CITY OF VANCOUVER
POLICY REPORT
DEVELOPMENT AND BUILDING

TO: Vancouver City Council
FROM: Director of Planning
SUBJECT: CD-1 Rezoning - 5429-5439 Willow Street

RECOMMENDATION

Project No: 1/8" SITE PLAN
Client: WILLOW STREET TOWNHOUSES

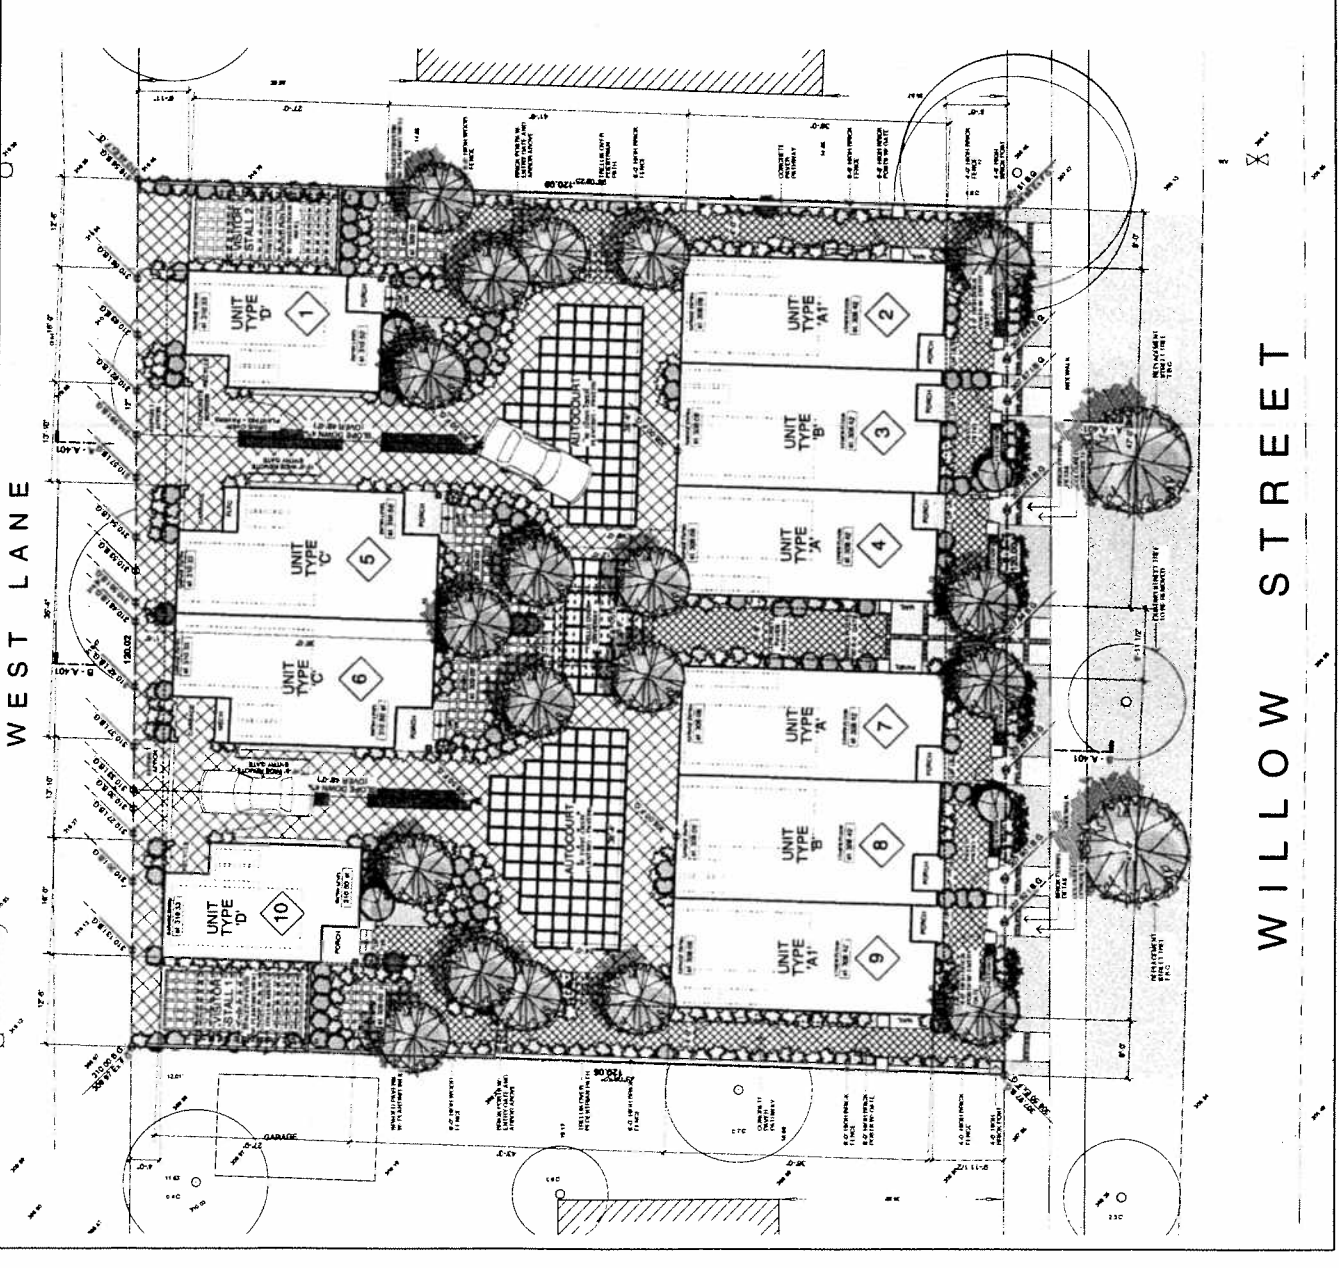
- (vi) Design development to the parking, removing all unenclosed surface parking, which includes the two visitor parking spaces at grade, and providing more private outdoor amenity space and landscaping.

- (ix) Further design development to the private and common outdoor space in the rear yard.

Note to Applicant: The detail design of these spaces differs as illustrated on the Landscape Plan and Site Plan. Adjust the layout of the private outdoor spaces to accommodate a secure common green space to connect with the lane. Replace the visitor parking spaces with green landscaped areas for common use. Refer to Design comment above.

- (x) Provide additional tree planting in the front yard (illustrated on the Landscape Plan).

Note to Applicant: Locate a new tree beside the pedestrian walkway at the south end of the site. New trees should be planted at 6 cm calliper for deciduous trees and 3.5 m high for evergreens, as per the Private Property Tree By-law.

1/8" ELEVATIONS
 EAST + SOUTH

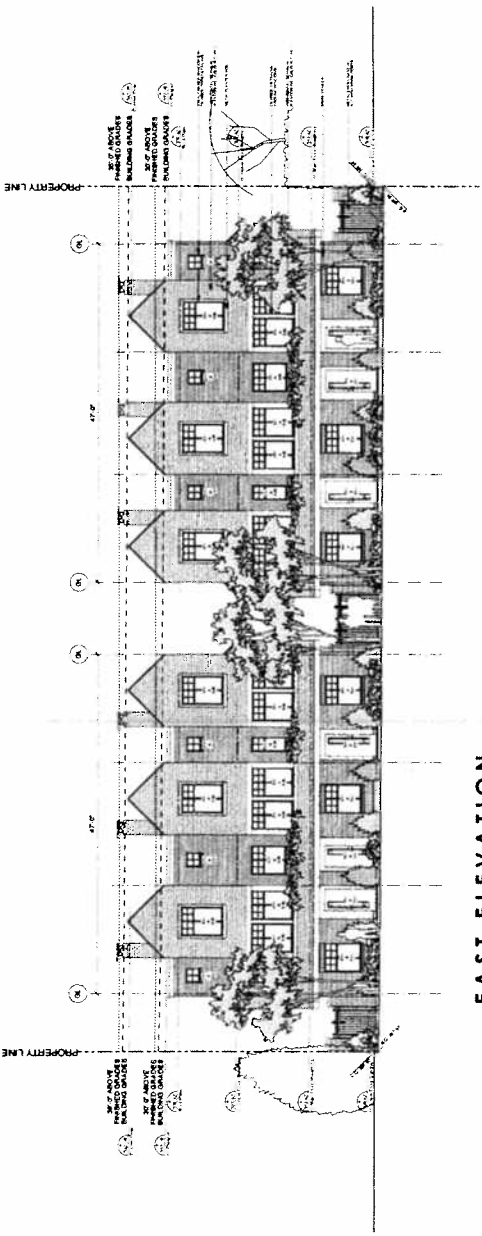
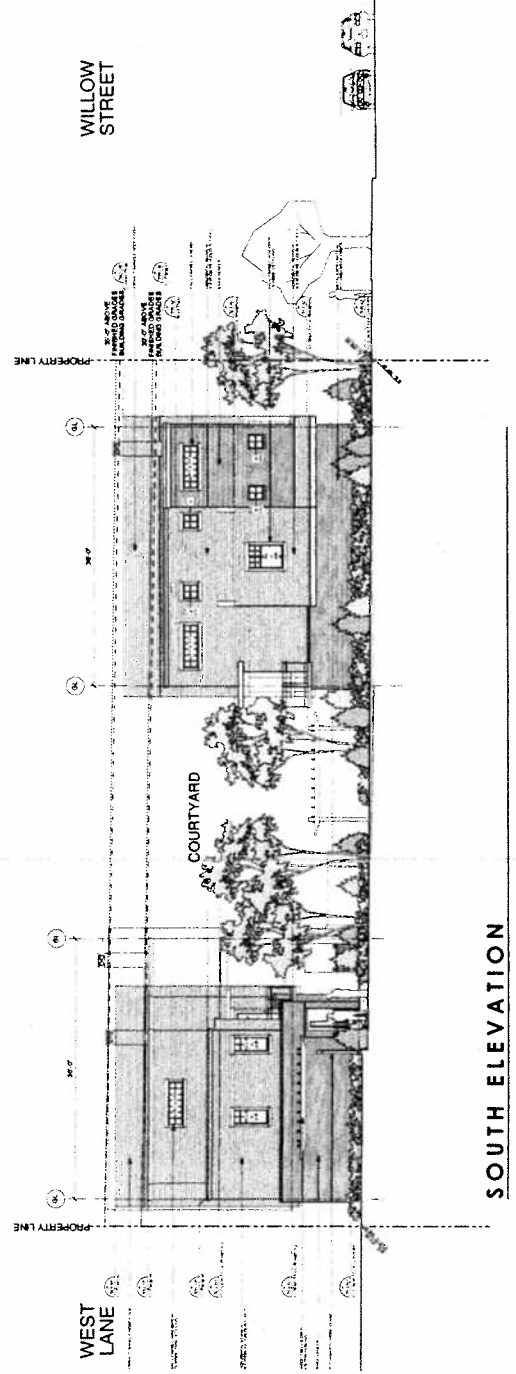
- (i) Design development to the building materiality, increasing substantially the amount of brick masonry on the building exterior.

Note to Applicant: The amount of brick masonry as indicated on the drawings is considerably less than what was earlier proposed. The applicant is advised that brick should be the predominate material, covering approximately two-thirds of the exterior walls. All building elevations should have a similar and consistent treatment, with equal amounts of brick on all building faces. Consider cladding the gable ends with brick as originally proposed.

- (iii) Design development to the building massing, removing the continuous planter box, street elevation.

Note to Applicant: Consider an alternative horizontal element(s) that is lighter and less boxy in appearance, while preserving the individual identity and vertical separation of the townhouse form.
